Mobile Intel[®] Pentium[®] 4 Processor-M

Specification Update

March 2004

Document Number: 250721-021

Figure 13. System Bus Reset and Configuration Timings

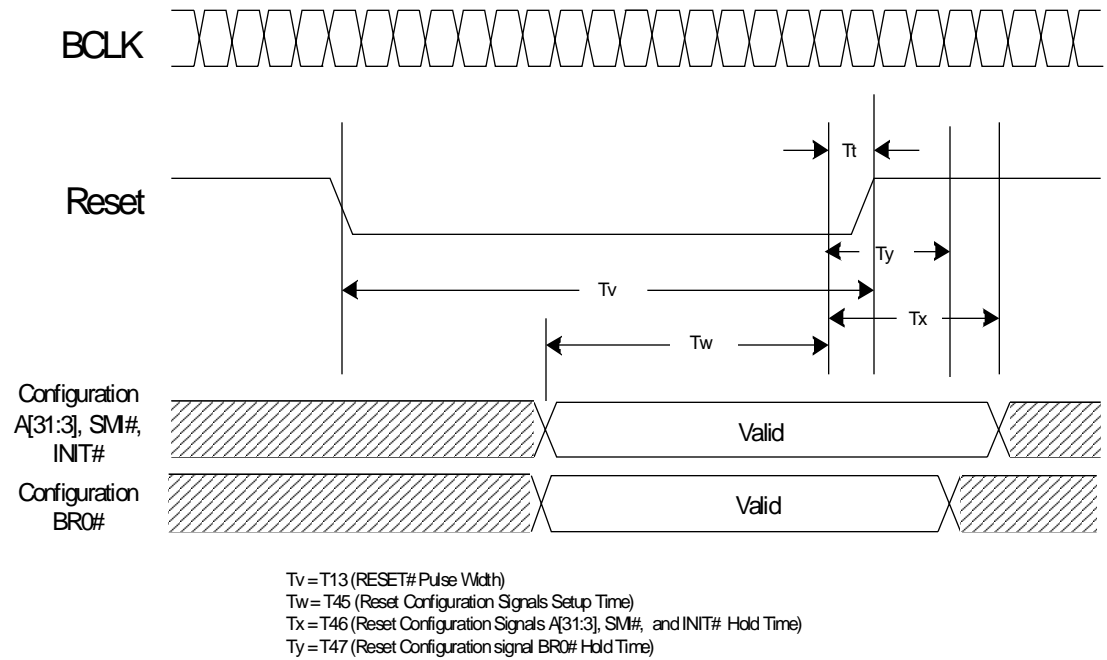
T2. BR0# Maximum Hold Time Specification Change

The BR0# maximum hold time has changed to 2 BCLKs. This change will be shown in the “System Bus AC Specifications (Reset Conditions)” table and “System Bus Reset and Configuration Timings” figure of the *Mobile Intel® Pentium® 4 Processor - M Datasheet*. This change will be incorporated in the next revision of the datasheet.

The following figure will be modified to reflect this change:

T# Parameter	Min	Max	Unit	Figure	Notes
T45: Reset Configuration Signals (A[31:3]#, BR0# INIT#, SM#) Setup Time	4		BCLKs	13	1
T46: Reset Configuration Signals (A[31:3]#, INIT#, SM#) Hold Time	2	20	BCLKs	13	2
T47: Reset Configuration Signal BR0# Hold Time	2	2	BCLKs	13	2
